**THE  
NATIONAL  
BOARD**  
OF BOILER AND  
PRESSURE VESSEL  
INSPECTORS

## **SUBGROUP ON HISTORICAL BOILERS**

### *AGENDA*

*Meeting of July 16, 2012  
Columbus, Ohio*

Exhibit 1

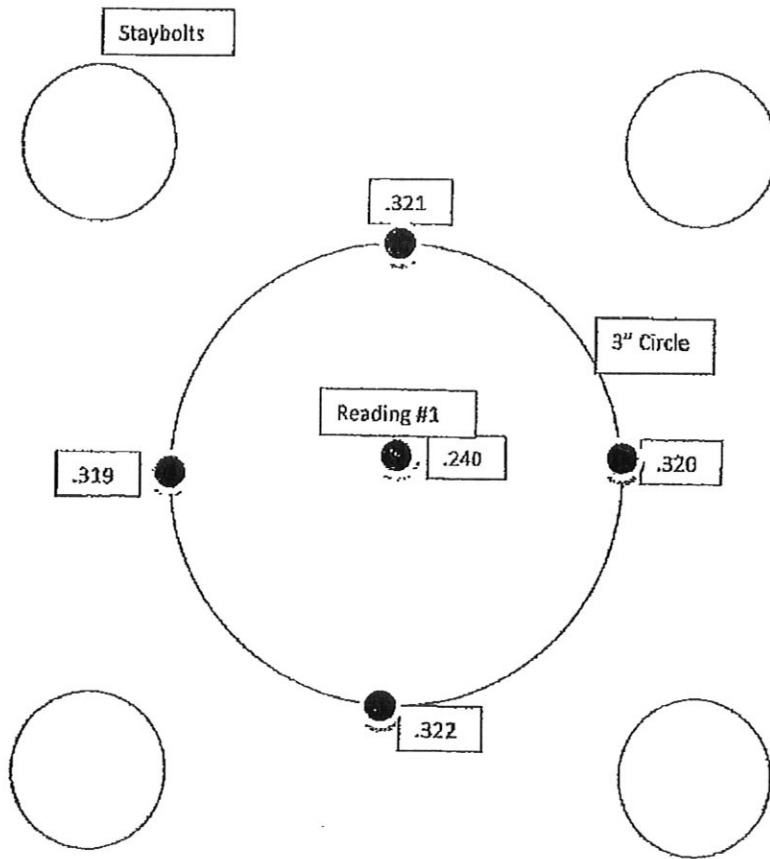
Part II, Section 6, Paragraph S2.6.2 b) should be revised to provide more guidance for evaluating local pitting corrosion versus general corrosion. See example below;

Once region of corrosion pitting is detected by UT (.240" in the attached illustration), a three-inch circle should be drawn around the pitted region. After four readings around the perimeter of the circle are determined by UT and show significant difference with the original lowest reading, the lowest of the four readings should be used as the actual thickness for that particular subsection of the boiler (e.g., the staybolt quadrant as shown, or the grid section of the barrel).

The lowest center reading is assumed to be a localized pit, and can be disregarded in the MAWP calculation because of surrounding material that provides some level of reinforcement.

Figure S2.10.2

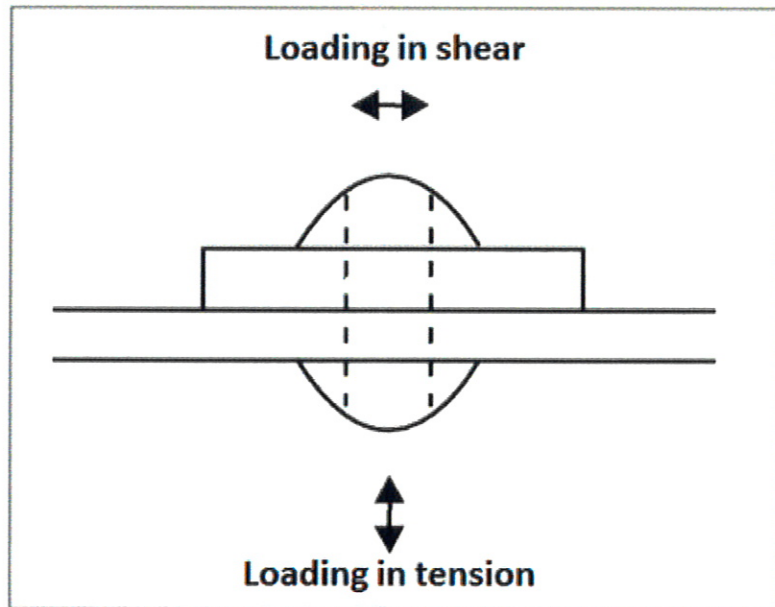
- a. Visually identify all connections containing rivets which show signs of significant corrosion.
- b. Categorize each connection as the type which loads the rivets in one of three possible modes (pure shear, pure tension, or combined shear and tension). Refer to Figure S2.10.2.

- ii. For rivets in pure tension, the amount of measured head deterioration shall not exceed 35% of its total head volume. Where rivets have countersunk heads, the head diameter must be equal or greater than 85% of original head diameter. Application of this value shall take into consideration the consistency and frequency of adjacent rivets showing excessive corrosion.

- iii. For connections subjected to combined shear and tension loads, the amount of measured head deterioration shall not exceed 60% of its total head volume. Where rivets have countersunk heads, the head diameter must be equal or greater than 75% of original head diameter. Application of this value shall take into consideration the consistency and frequency of adjacent rivets showing excessive corrosion.

The condition of the plate surrounding the rivets including general wastage, pitting, and the condition of the caulking edge, must be considered.

Figure 12 - Max. Stress Vs. Loss of Head Volume (Uniform Model)

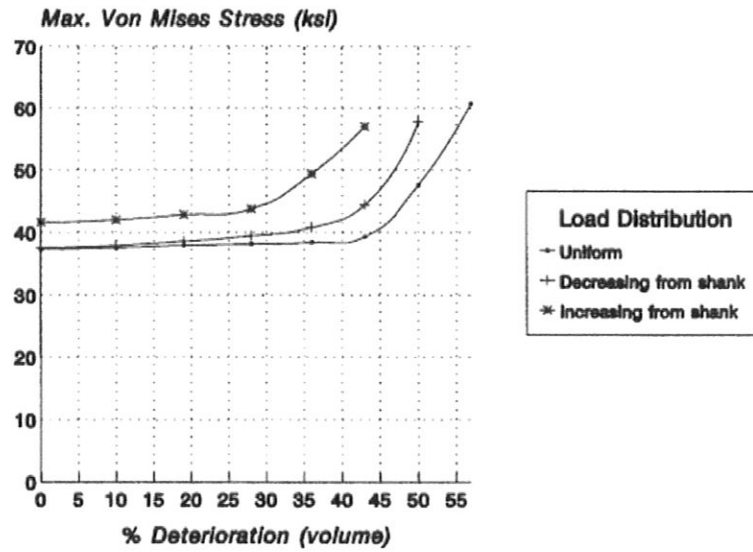
[8] is heavily referenced, and states that current practice is to replace all rivets in connections subject to tensile or tensile-shear loading that have heads corroded to the point of losing 50% or more of their projection beyond the shank. An original copy of this publication could not be sourced, but this wording is consistent among all papers referencing this work.

**US Army [2]: minimum head volume =  $0.65 * \text{original head volume}$**

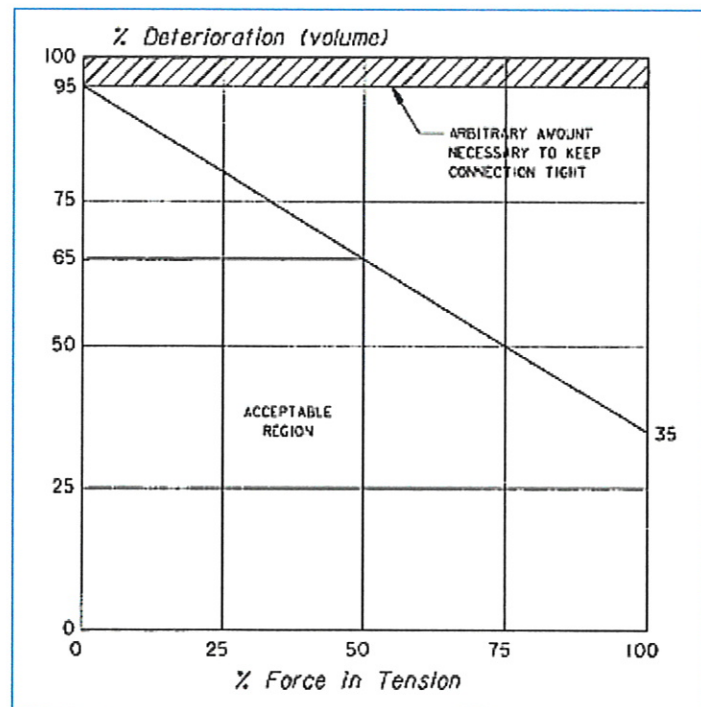
Assuming even deterioration at the rivet head crown, but no deterioration at the edge of the rivet head (red line), to obtain 35% removal of head volume, 'h' must only reduce by **20%** of its original height. Using NBIC S1.4.2.1 metrics, 'h' must be **40%** or greater than shank diameter.

Assuming even deterioration throughout the rivet head, to obtain 35% removal of head volume, 'h' must only reduce by 17.5% of its original height. Using NBIC S1.4.2.1 metrics, 'h' must be 46% or greater than shank diameter.

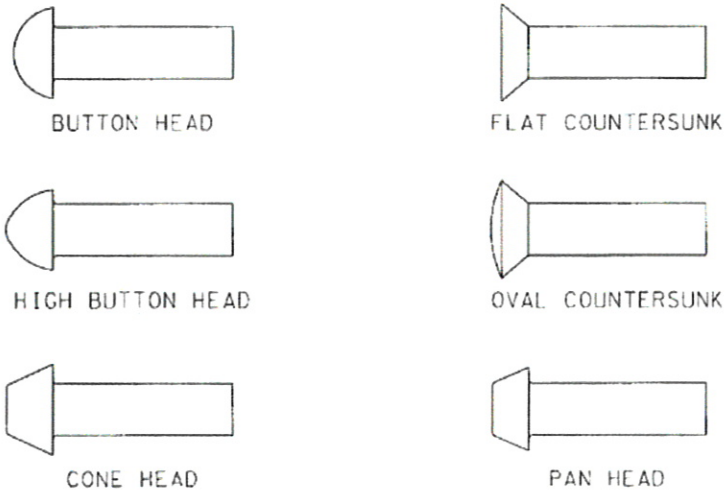
[2] also suggested that for rivets in pure shear, rivets do not need to be replaced as long as the corrosion has not extended into the shank and that the rivet is not loose. Furthermore, the ratio of total head volume removed may linearly scale from 35% (for 100% tension) to 95% (for 100% shear). Refer to below figure from [2].

adopts the rule to apply equal 50/50% shear/tension. Given the above text, allowable head corrosion for rivets in combined shear/tension is 60%; consistent with NBIC S1.4.2.1.

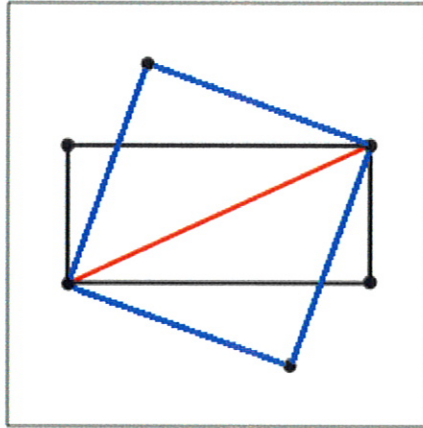
**Explanation:** All known course materials and interpretations of all editions of ASME interpret PG-46.1 (STAYED SURFACES) to require application of the largest dimension of the rectangular pattern as the dimension of ‘*p*’ in the familiar equation:

(also used in S2.10.4). This wording and interpretation is duplicated in ASME Section VIII UG-47. However, ASME 1971 PFT-27.1 and ASME 2002 PFT-26.1 both use similar wording stating “*The full pitch dimensions of the stays shall be employed in determining the area to be supported by a stay...*”. We interpret this wording to mean true dimensions of a rectangle.

All editions of the Canadian Interprovincial Standard (1910-1938) provide a variation for the same equation for flat stayed surfaces. Specifically, the dimensions of a theoretical square with the same hypotenuse as that of the rectangle, is used. It is believed that, in this respect, the ASME code is a simplification of the older Canadian code and underlying theories. Additionally, traction engine blueprints and registration documents have shown that many historical boilers were built to this Canadian standard. For these reasons, this proposal is based on this precedent.
